<b>Model</b>	Sorter Adapter Type J	<b>Volt/Hz</b>	<b>Date of Modification</b>	<b>Serial Number</b>
<b>Modified Article</b>	Parts Catalog	No serial number for this model.		
<b>Reason for Modification</b>	Parts CatalogCorrection

Model	Sorter Adapter Type J	Volt/Hz	Date of Modification	Serial Number
Modified Article	Air Outlet Plate	No serial number cut-in information		
Reason for Modification	To improve the air flow

Model: DFC-Alpha Sorter Adapter Type J		Date: 15-Oct-98	No.: 3
Modified Article: Fan Motor Bracket		Prepared by: N. Kaiya	
From: GTS and S Field Information Dept.			
Reason for Modification:	<input type="checkbox"/> Parts catalog correction <input type="checkbox"/> To facilitate assembly <input type="checkbox"/> Part standardization	<input type="checkbox"/> Vendor change <input checked="" type="checkbox"/> To improve reliability <input type="checkbox"/> Other	<input type="checkbox"/> To meet standards (      )

Model: DFC-Alpha Sorter Adapter Type J		Date: 31-Mar-03	No.: MA527004
Modified Article: Fan Motor Harness		Prepared by: H. Matsui	
From: Technical Services Sec. Service Planning Dept.			
Reason for Modification:	<input checked="" type="checkbox"/> Parts catalog c

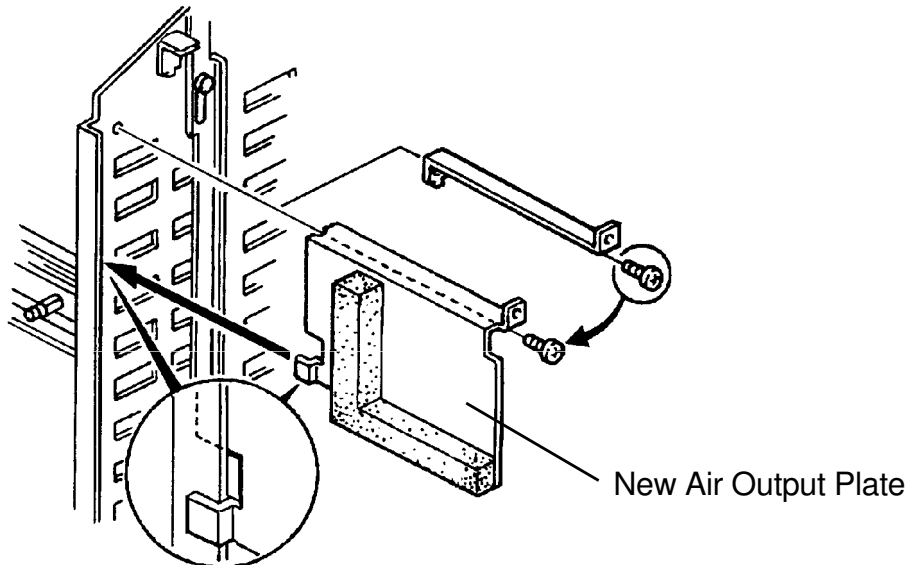
Please correct your parts catalog as follows.

Incorrect P/N	Correct P/N	Description	Q'ty Used	Inter-change-ability	Parts Catalog	
					Index No.	Page
03410300B	03140300	Philips Pan Head Screw - M4 x 30	2 → 2	O/O	101	3

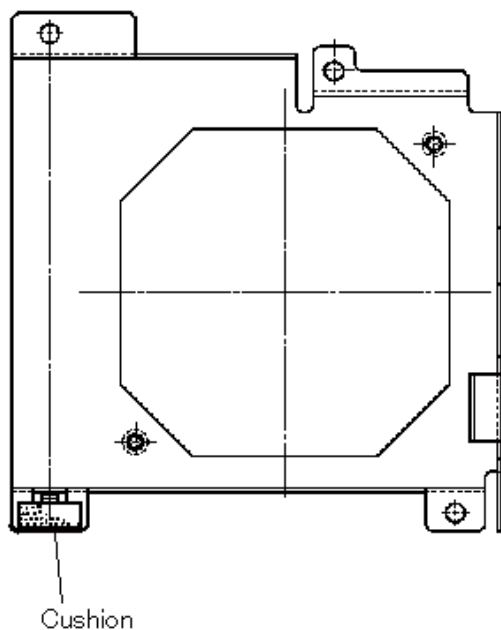
The charge inlet fan may draw in air blown out from the fusing unit which may result in abnormal copy quality. To prevent this problem, the air outlet plate has been modified. The number of Philips pan head screws has been reduced from 9 to 8 since new plate uses a screw from the sorter.

Old P/N	New P/N	Description	Q'ty Used	Inter-change-ability	Parts Catalog	
					Index No.	Page
A527 1042	A527 1045	Air Outlet Plate	1 → 1	X/O	3	3
	0314 0060B	Philips Pan Head Screw M4 x 6	n → n-1		103	3
